Vehicle	FIAT / Stilo 1.9 JTD 8V / 10/2001 - 12/2003 / Squareback/hatchback limousine
Country of manufacture	I
Cubic capacity/Power	1.9 / 85 kW
Motor tag	192 A 1.000
RB key	FIA 1618

Known fixes and bulletins

Bulletin

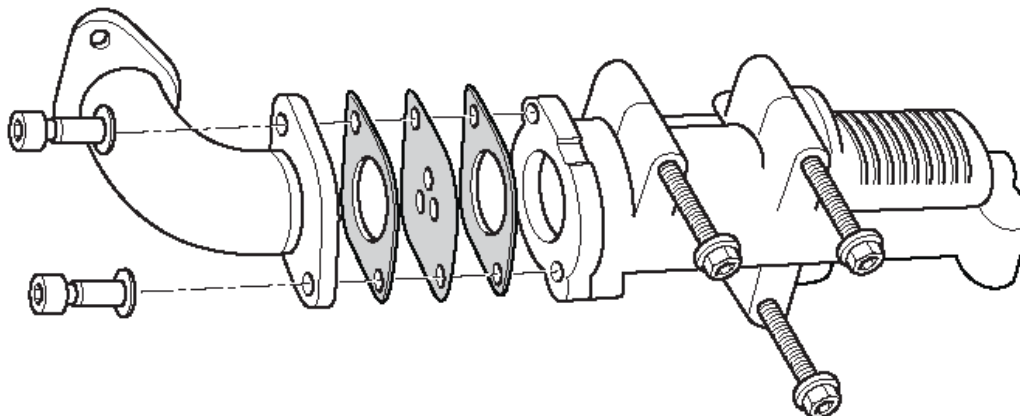
- Check intake system for leaks.
- Check mass air flow (MAF) sensor.
- Check for oil in intake system.
- Check fuel injectors for leaks.
- Check fuel injectors for correct type.
- Ensure EGR system operates correctly.
- Remove EGR valve and fit restrictor plate:
 - 1,9D JTD/Multijet/16V/2,4D JTD 20V Fig.1.
 - 1,9D JTD 8V Fig.2.

Parts			
Description	Part number	Engine	Quantity
Restrictor plate	71751468	1,9D JTD/Multijet/16V/2,4D JTD 20V	1
Gasket	55191883	1,9D JTD/Multijet/16V/2,4D JTD 20V	2
Restrictor plate	71751468	1,9D JTD 8V	1
Gasket	55191883	1,9D JTD 8V	2
